Hurricane Planning Commission Meeting Agenda

June 9, 2022
6:00 PM

Agenda Date:	06/09/2022
Application Number:	2022-PSP-19
Type of Application:	Preliminary Site Plan Application
Action Type:	Administrative
Applicant:	R+B Young
Agent:	Bryson Young
Request:	Approval of a Preliminary Site Plan
Location:	470 E 800 N
Zoning:	HC
General Plan Map:	General Commercial

PRELIMINARY SITE PLAN FOR:
BRYSON YOUNG
LOCATED IN SECTION 26, T41S, R13W, S1B.4M.
HURRICANE, WASHINGTON COUNTY, UTAH

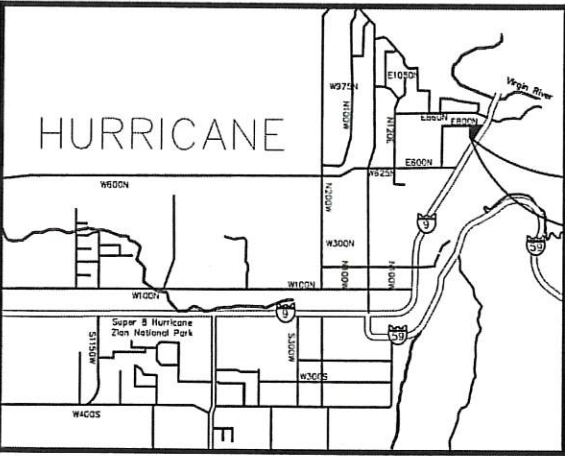
1. **Power:** Power available at northwest corner of property, this powerline may need to be upgraded at developer cost from State Street and 800 N. Keep the detention basin out of PUE. Must provide voltage and amperage calculations before design.
2. **Sewer:** Private maintenance of 8" line and manholes within property boundary
3. **Street:** Check for adequate parking
4. **Water:** Need water model for water meter size. Fire sprinklers required. City owned water line in private property must be ductile
5. **Engineering:** Check that accesses line up with access across the street. No detention basin or buildings in PUE.
6. **Fire:** Good for now, different uses may require different standards

1. The property is zoned Highway Commercial. The uses shown on the site plan are permitted uses within this zone.
2. More information is needed about the nightly rental units. Nightly rentals are allowed in commercial zones as they are substantially similar to a hotel, however there are development standards for hotels that must be followed and it is not clear that that is what the applicant is intending. These are:

3. The site plan currently calls for 24 parking spaces. Depending on the uses of the buildings the exact number of spaces will be determined but as it currently stands the plan is probably insufficient.

- 4. A full landscaping plan will be required with the final site plan
- 5. There is a "Welcome to Hurricane" sign near the southeast corner of the property on its own lot owned by the city. It appears on this plan that buildings will block the view and access to the sign. The City probably cannot require them to provide a viewshed or access to the sign but it would be nice.

Recommendation: Staff recommends the Planning Commission review this application based on standards with Hurricane City Code. Staff would recommend continuing this item unless the applicant can address the parking issues and the onsite management for motel use.

PROPOSED ZONE CHANGE MAP FOR:
JEFFREY HATCHER

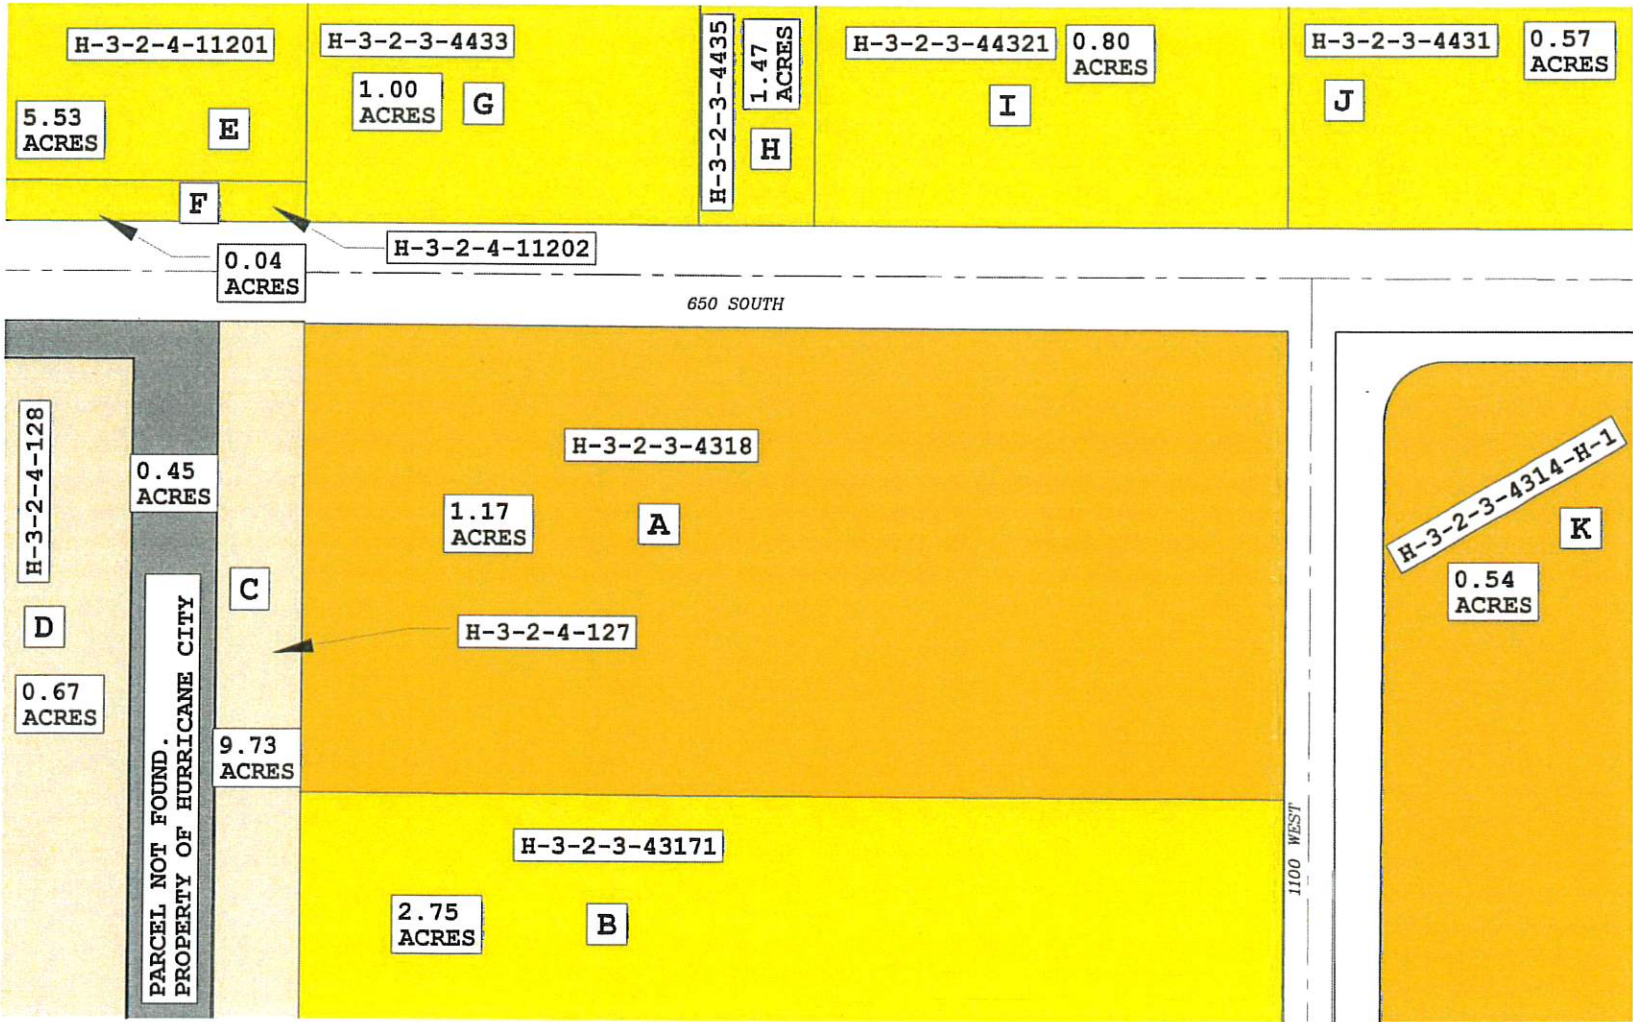
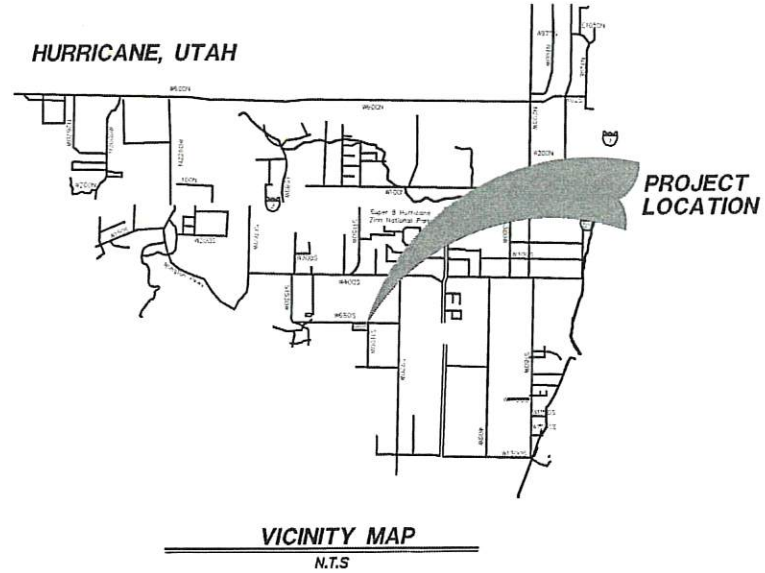
1. **Power:** No major concerns.
2. **Sewer:** No issue with zone change.
3. **Streets:** Okay with zone change
4. **Water:** No issues. Water line in 650 S.
5. **Engineering:** 650 S is a master planned minor collector. 1150 W is a master planned minor collector with a 12' trail on the east side. 1100 W is an incomplete roadway, however the ROW may have already been dedicated. Road improvements will be constructed with the proposed lot split. Complete legal description needed.
6. **Fire:** Fire code analysis needed
7. **Cable/Phone/Gas/WCWCD:** Good

1. There is a 60'' master planned roadway (Future 1150 W) that needs to be dedicated on the property. Half of this roadway is already dedicated.
2. 650 S is master planned as a 60' minor collector. 15' of road dedication is required on the north side.
3. 1100 W needs curb, gutter and sidewalk
4. It is possible that all three roadway improvements are beyond the proportional scope of a single lot split. City staff is willing to negotiate a compromise with the property owner on this issue,

5. Due to the required roadway improvements a preliminary plat will need to be submitted by the applicant if this zone change is approved.

Recommendation: Staff recommends the Planning Commission review this application and the zone change based on standards and consider residents' comments. Staff recommends approval of the proposed zone change.

**ZONE CHANGE EXHIBIT
RESORT RECREATION
PECAN VALLEY**

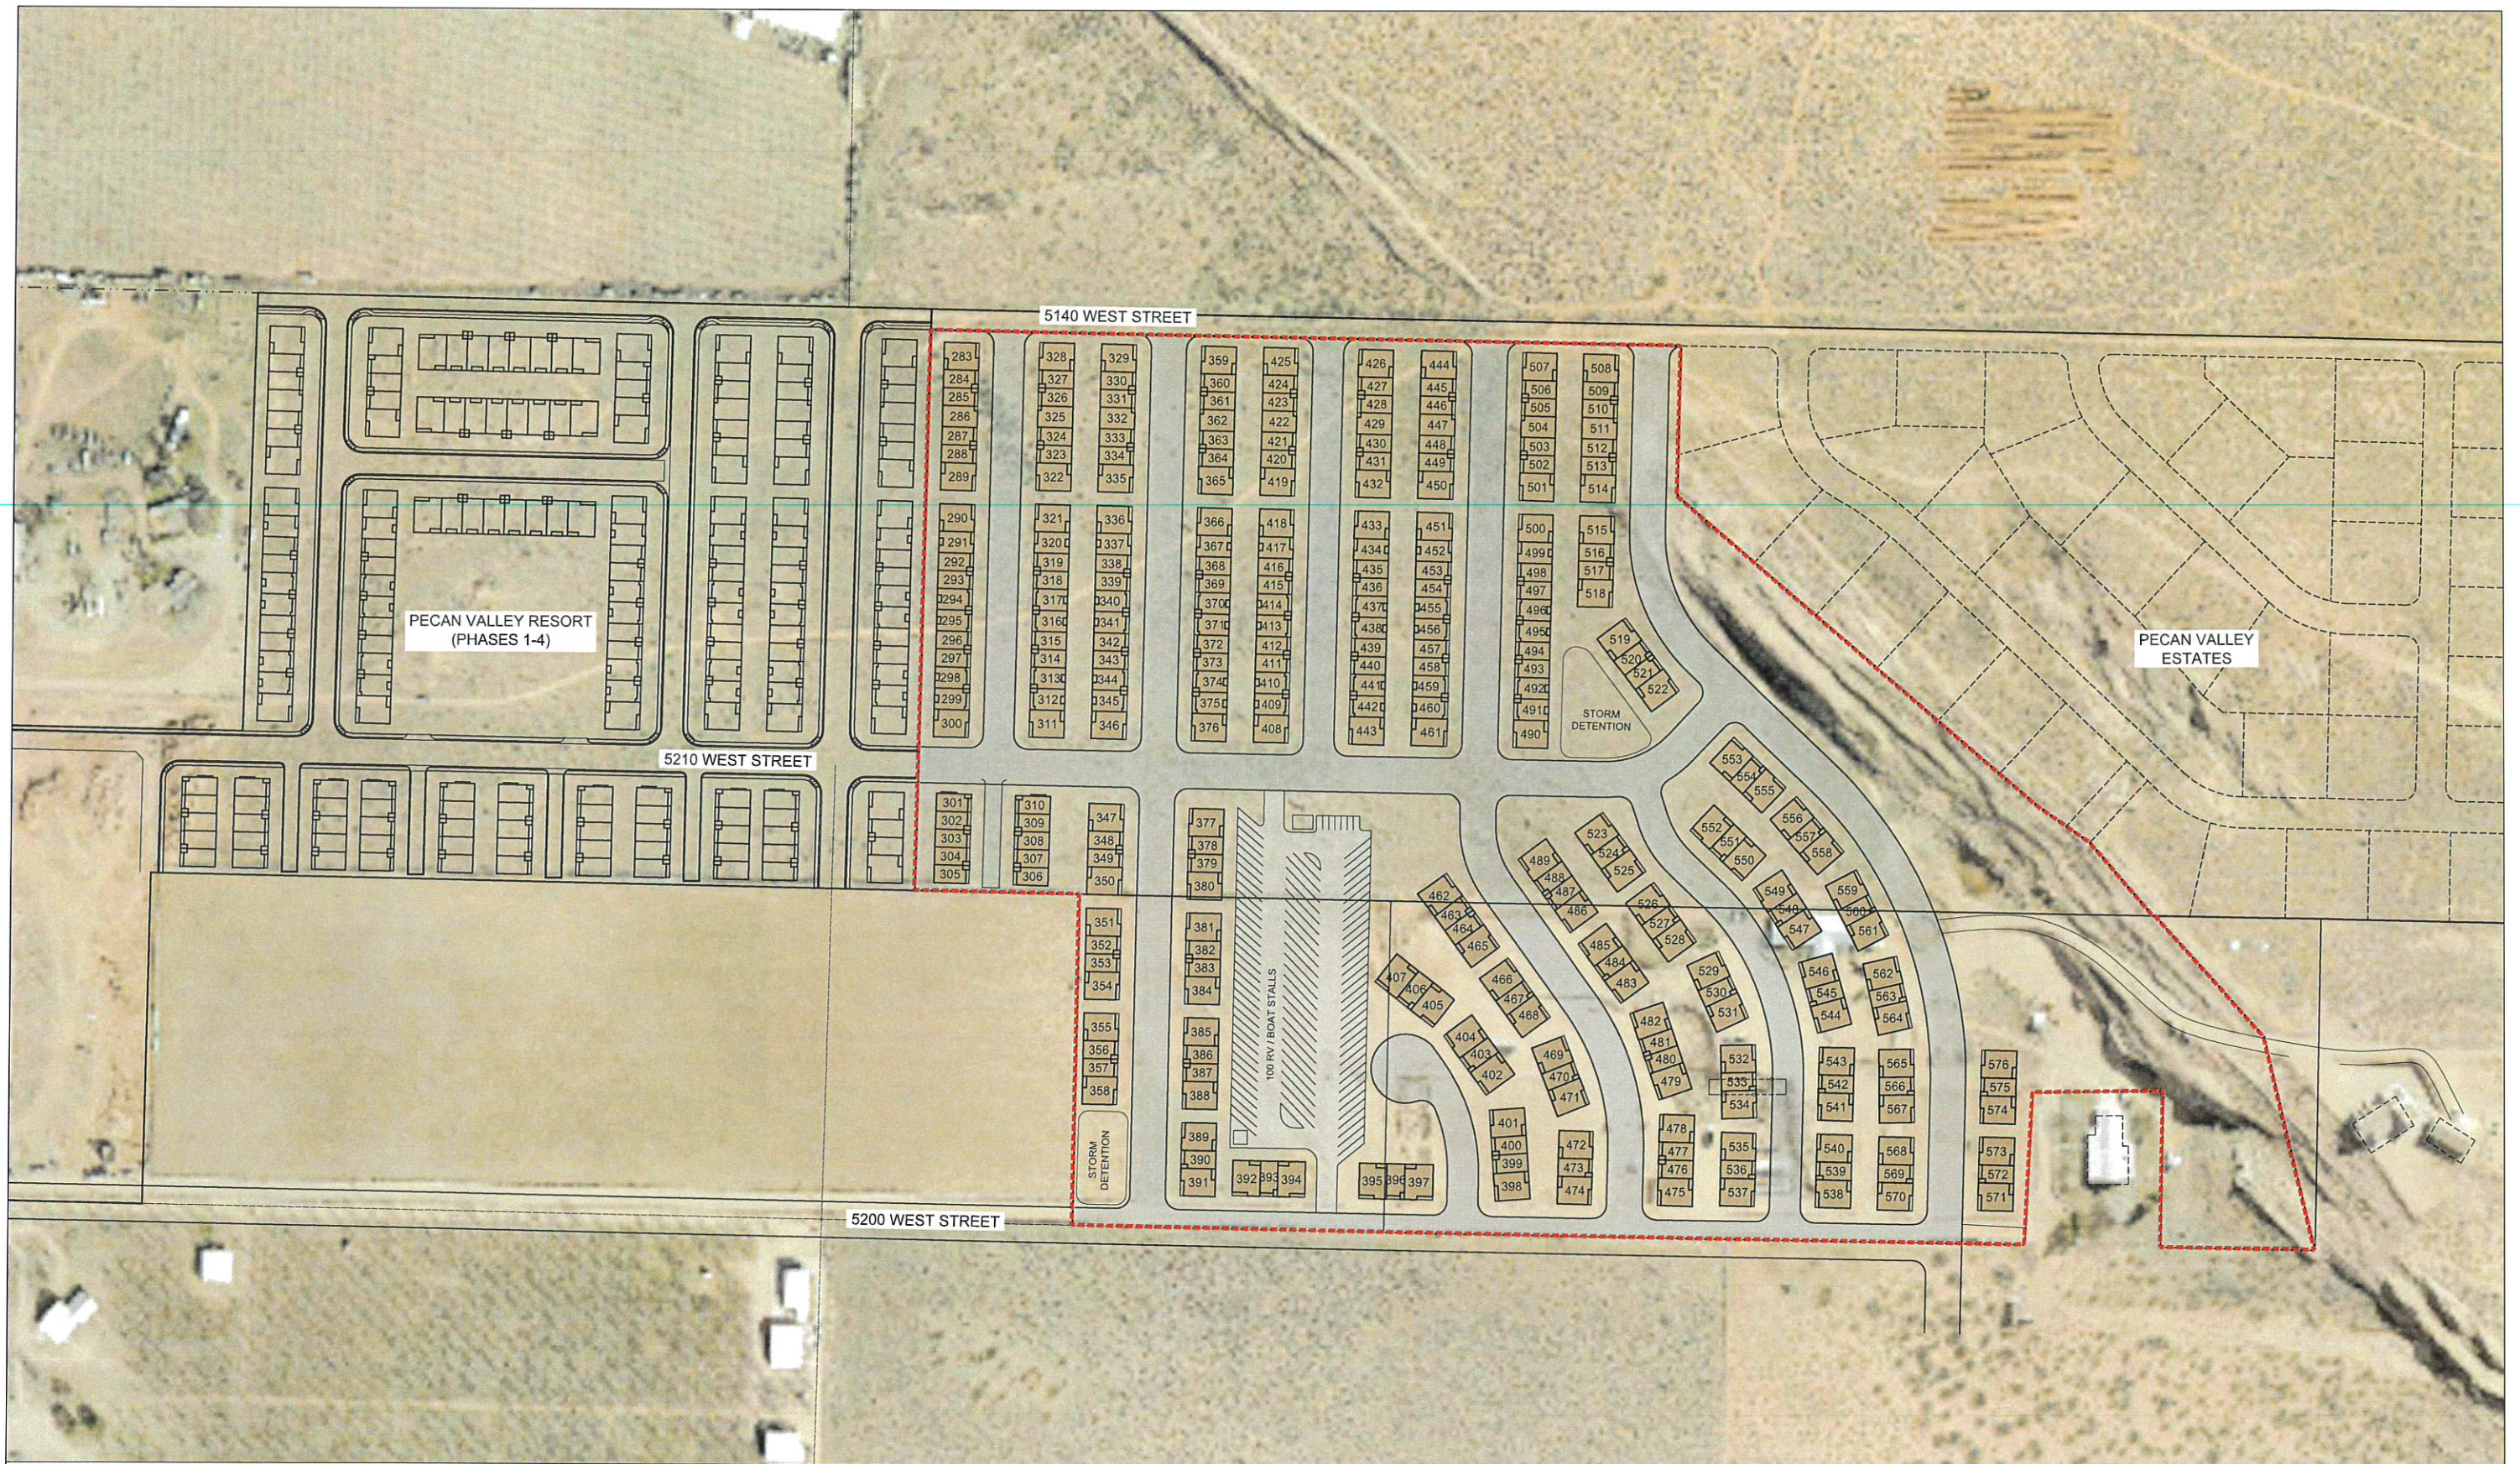
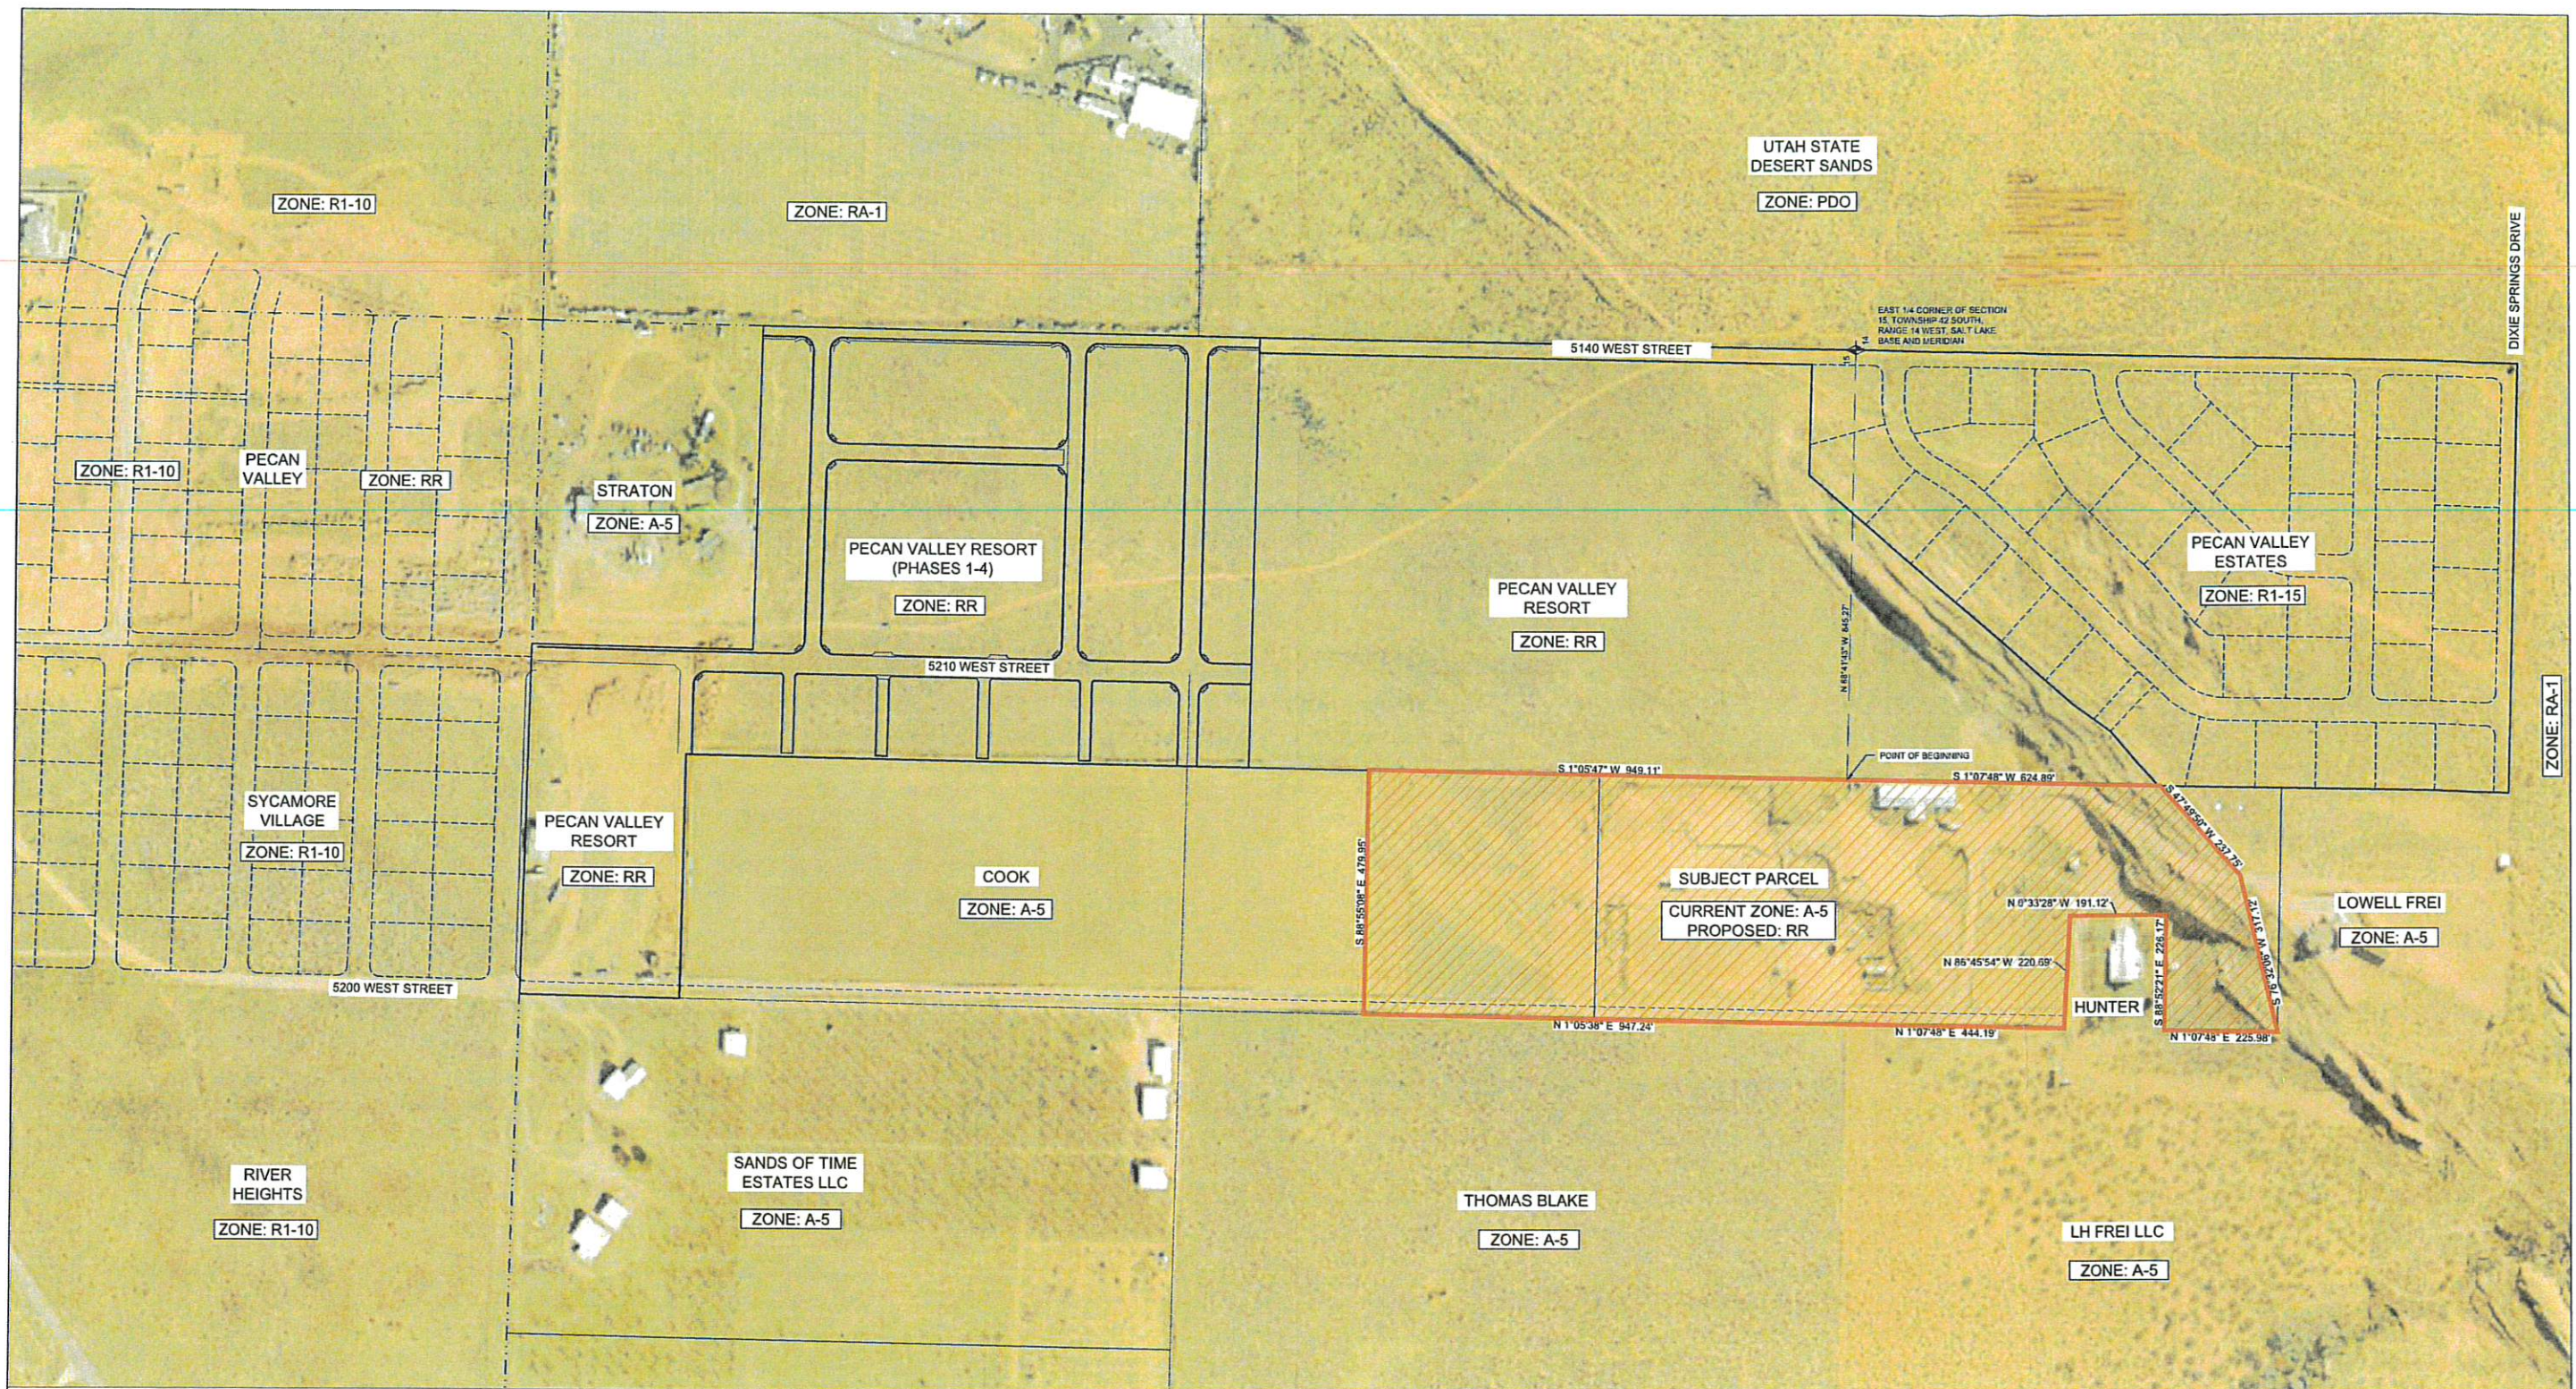
1. *Within recreational resorts, an application shall provide two parking spaces per unit or one space per bedroom, whichever is higher. Tandem parking spaces are permitted only if approved as part of the preliminary site plan by the Planning Commission.*
2. *RV and Trailer Parking: An applicant shall provide sufficient parking areas for RV's and trailers. A minimum of one RV/trailer parking space shall be provided for every 5 units.*
 - a. More information is required but one would presume all of these units will have garages to fulfill part 1's requirement
 - b. 100 RV/boat stalls are provided which is sufficient for this phase of the development.

3. **Amenities:** Per Hurricane City Code 10-26-4: 3 clubhouses with 3500 sq ft of total non office space and 5 pools of at least 3000 sq ft total are required. Earlier phases of Pecan Valley Resort provided at least 2 clubhouses and 2 pools. As well:
 - a. *These amenities should be centrally located and have walking trails or sidewalks for access. Where applicable, multiples of amenities should be placed throughout the property to ensure equitable access.*
 - b. With these newer phases the amenity areas are now clustered towards the north end. Staff would recommend another amenity area be located near the southern end
4. A table providing the percentage of building coverage should be provided
5. The southernmost roadway running east-to-west creates a double-fronted lot in Pecan Valley Estates. Double fronted lots are not permitted by city code

1. The application only partially meets the standards set by the General Plan and the General Plan Map.
2. Generally, the uses are harmonious with some but not most of the surrounding development.
3. The proposed amendment will have an impact on the area.
4. Services are currently inadequate to serve the area and proposed project but plans are already in motion to get services near this property.
5. The application does not meet many of the requirements of rezoning a property to Recreation Resort
6. The Preliminary Site Plan provided is missing some key items required in the Recreation Resort zone

Recommendation: Staff recommends the Planning Commission review this application and the zone change based on standards and considers residents' comments. Staff would recommend denial of this zone change.
